Date: 3 August 2008
To: Plan Commission members
From: Chris Schmidt, Chair,
Westmorland Neighborhood Association
Planning and Development Committee (WNAPDC)
Re: Sequoya Commons Phase II

Re: Sequoya Commons, Phase II

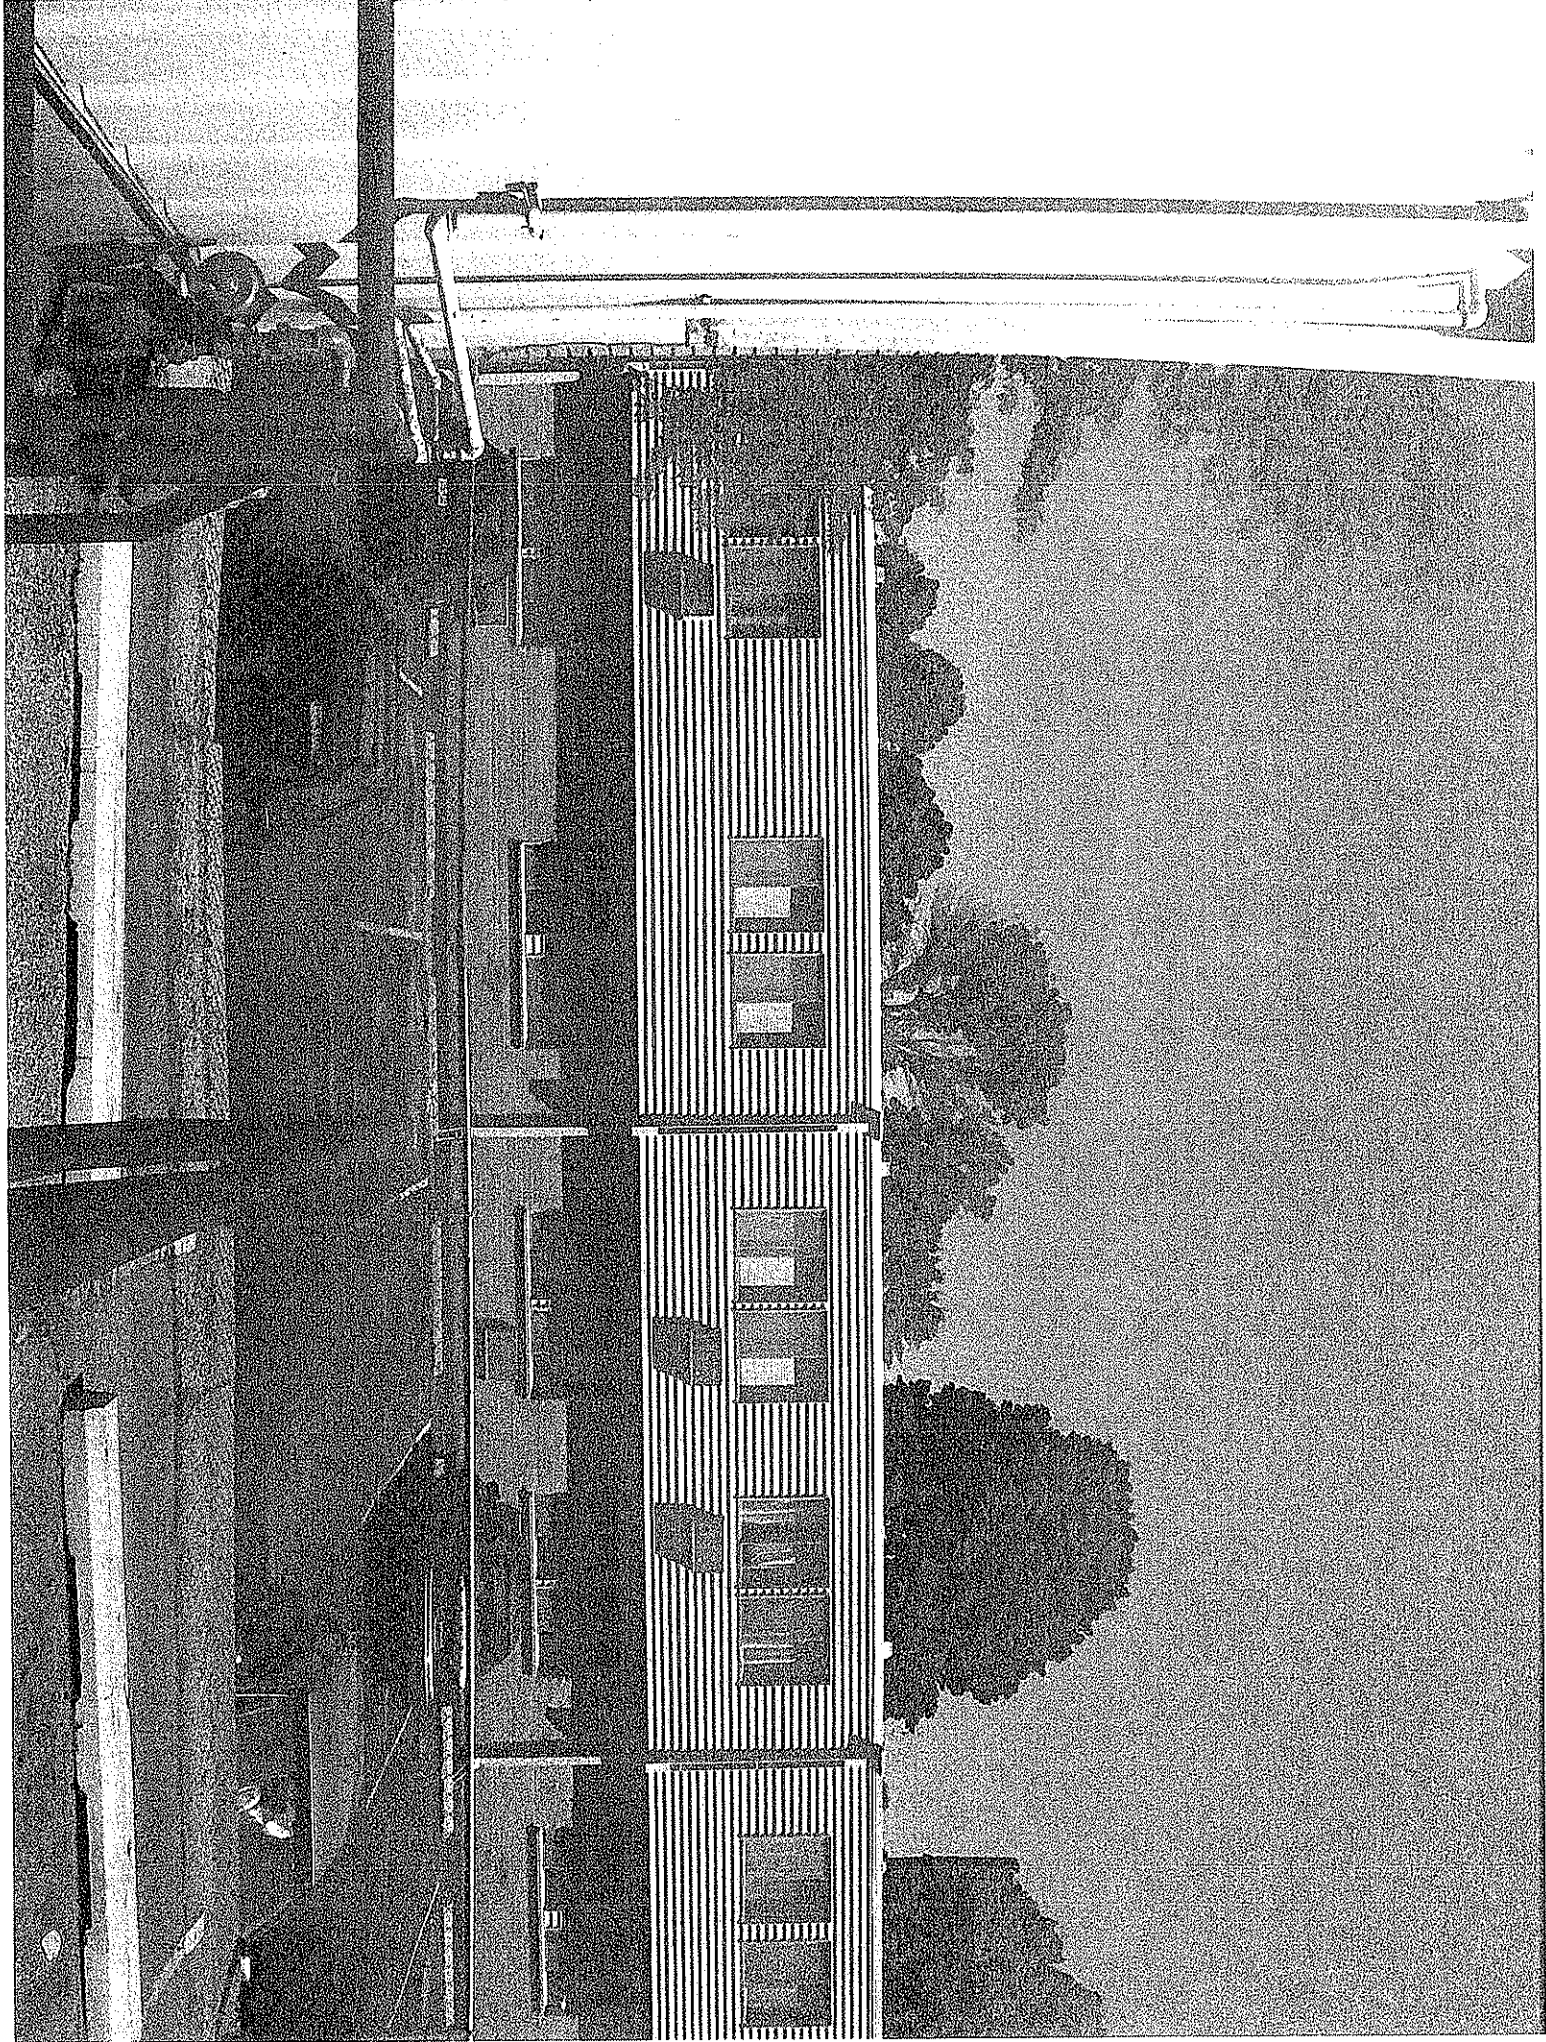
My main area of concern about this construction project remains pedestrian safety. Any Caromar Street garage entrance of the Phase II building is not acceptable. The intersection of Caromar and Owen is a major pedestrian approach to this project.

With additional occupied retail space and a larger library (already one of the busiest in the state), I anticipate that foot traffic to this area will only increase. The vehicular traffic generated by the 140 parking spaces in the underground parking for Phase II of Sequoya Commons will place an inappropriate burden on the residents of the Westmorland neighborhood.

When you cast your vote, please consider the wishes of the neighbors, who are major library and retail patrons. Make this a development that welcomes pedestrians. Please vote for the entrance to this development onto Midvale Blvd.
